Stormwater Management Plan

Project:	Dowerin Peak Planning 2026
Client:	CBH
Author:	B. Smith
Date:	25 th August 2026
Shawmac Document #:	2608011-SWMP-001
CBH Document #:	361-P-01452-CI-RPT-0001

Responses to EHO-RA info requests:

Subject: RE: Attention SHAWMAC B. Smith & R. Needham RE: SHAWMAC Document 2608011-SWMP-001 Additions to Existing Grain Handling Facility – Development Application - Lot 25 on Deposited Plan 425195, Dowerin

Figure 3: Proposed Drainage Strategy

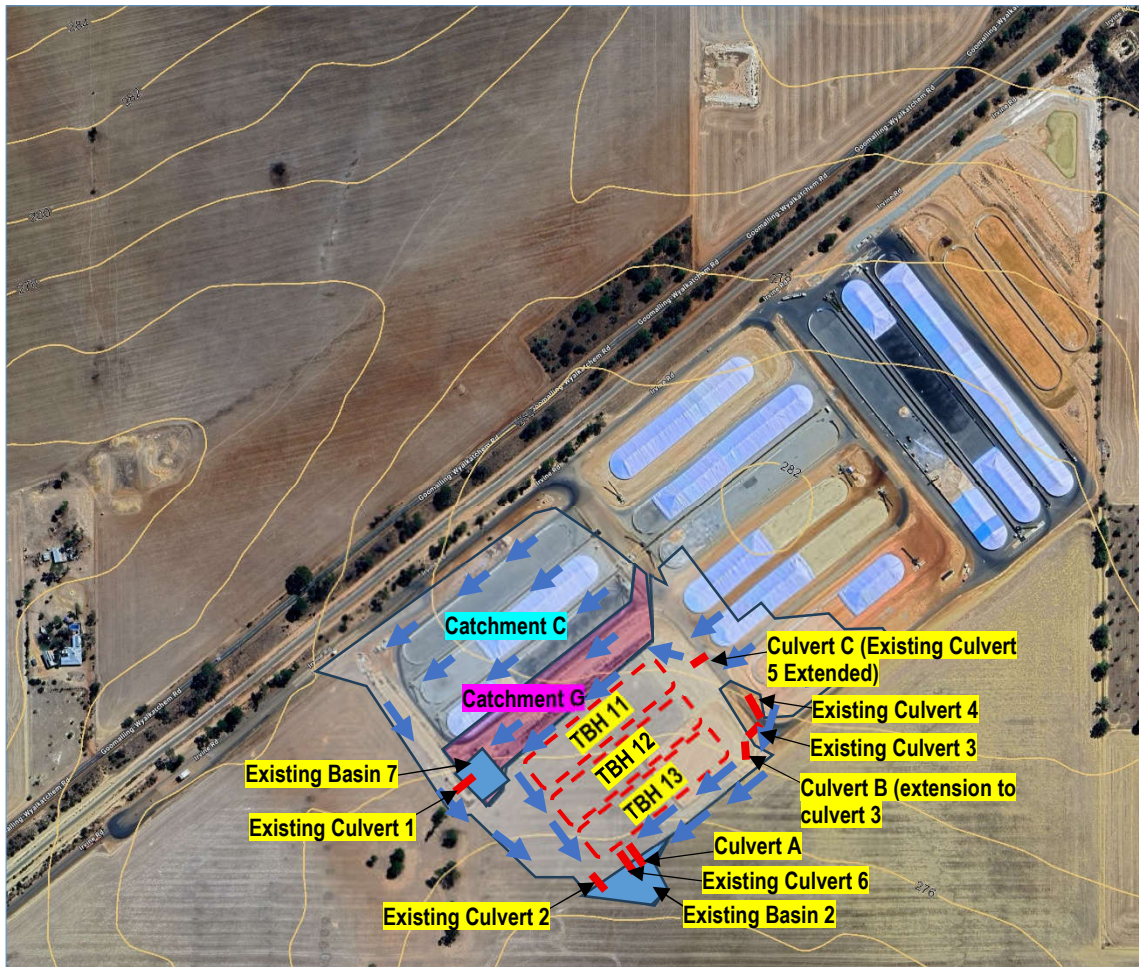
1. 5-year ARI and 20% AEP terminology are interchangeable.
 2. There is one existing culvert as shown in Table 2 where we are not achieving the 300mm freeboard. This culvert only conveys stormwater from the existing site. We need to extend it, but the issue is there regardless of the expansion. Personally, I don't think this is a big issue - 220mm is achieved, the deficient freeboard only occurs for a few minutes at the peak of the event, it doesn't affect any external areas and CBH carries the risk of any damage. Otherwise, no issue with the proposed condition.

Figure 4: XPStorm Modelling & Analysis

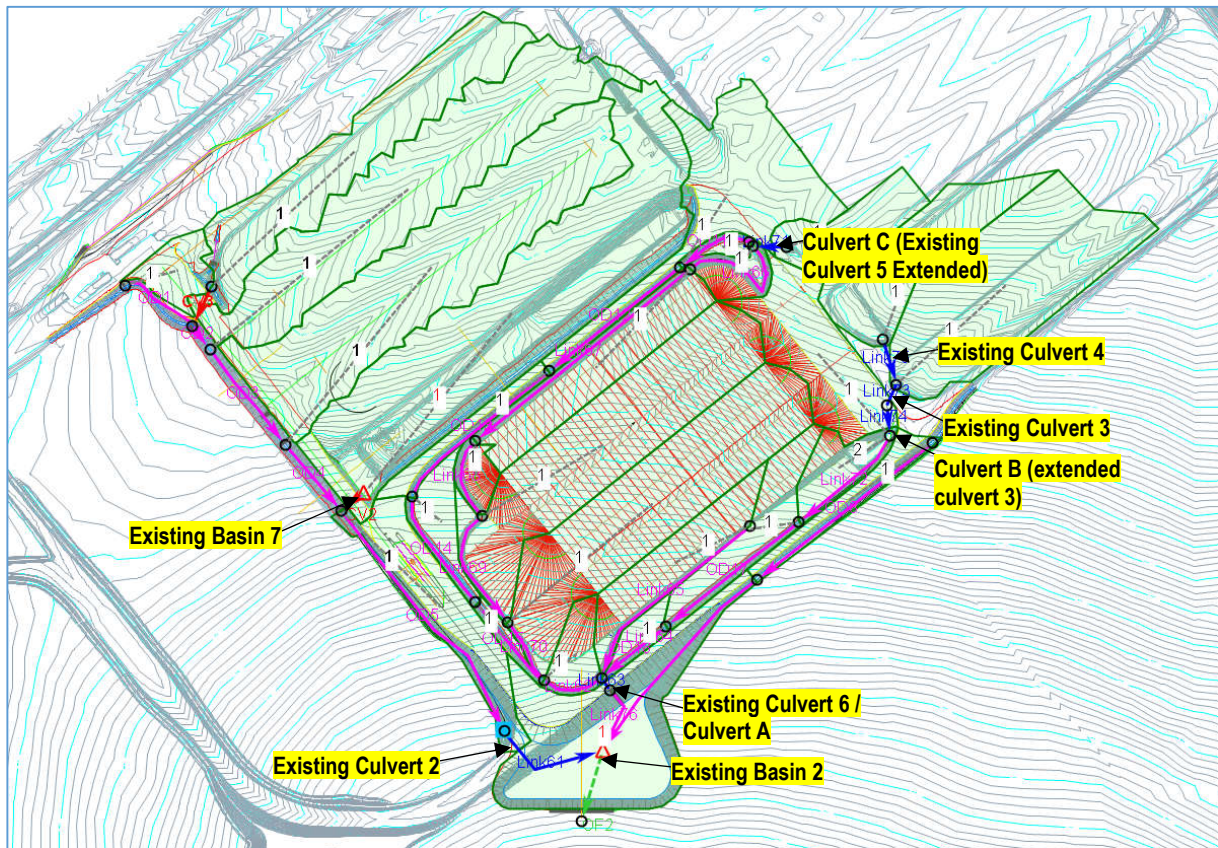
3. The previous version of the SWMP assessed the 20-year event for permanent infrastructure, so the modelling outcomes aren't comparable. There's no change in the basin size in the models, but the top area and volume have been presented differently in both reports (latest report is more correct). Apologies for the confusion. The report is intended to show that the basins which were built for the 20-year event under the previous works have capacity to contain the 5-year event for the whole catchment once the new works are built. This is demonstrated by the available freeboard. There's no additional compensation provided, it's just the difference in the design events. Where we've mentioned 30% design, this is just stating that the design has a maturity of 30% i.e. it's not fully completed yet.
